# City of Ketchum

## Recommendation to hold a public hearing and approve the Waddell-Roush Townhouse Subdivision Preliminary Plat

IN RE: )  
 )  
 Waddell/Roush Townhomes Subdivision ) **KETCHUM CITY COUNCIL**  
 Preliminary Plat ) **FINDINGS OF FACT, CONCLUSIONS OF LAW, AND**  
 Date: November 16th, 2020 ) **DECISION**  
 )  
 File Number: 20-058 )

**Figure 1.**  
Proposed Townhouse Plat Excerpt

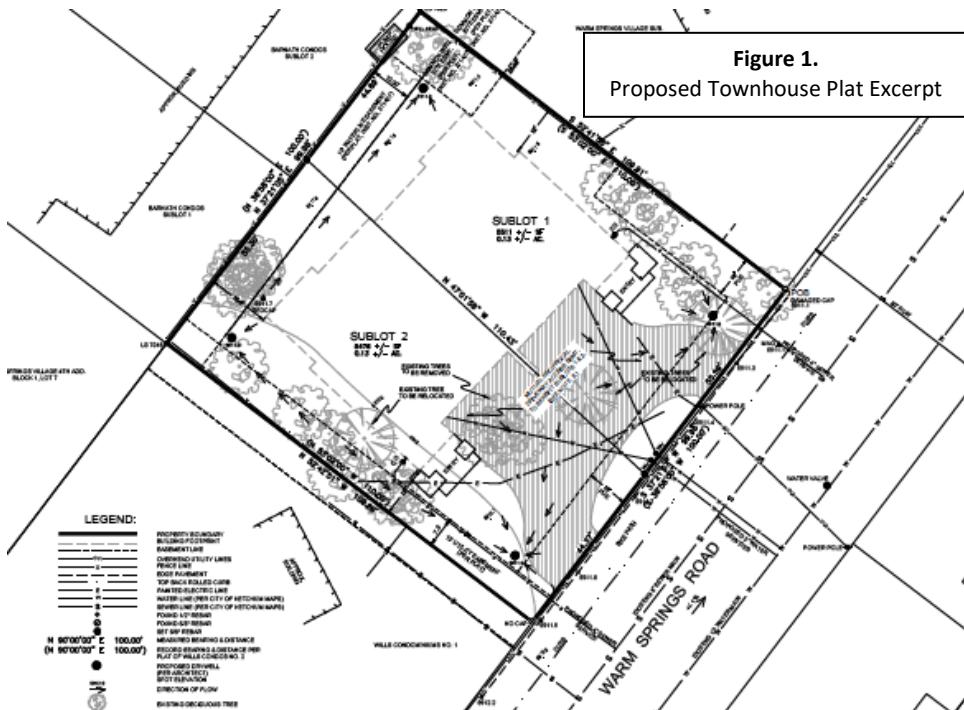
All city departments have reviewed the Preliminary Plat and have no issues or concerns with the application at this time. No public comments regarding the application have been received to date. Any public comments received after publication of the staff report will be included in the record and forwarded to Council.
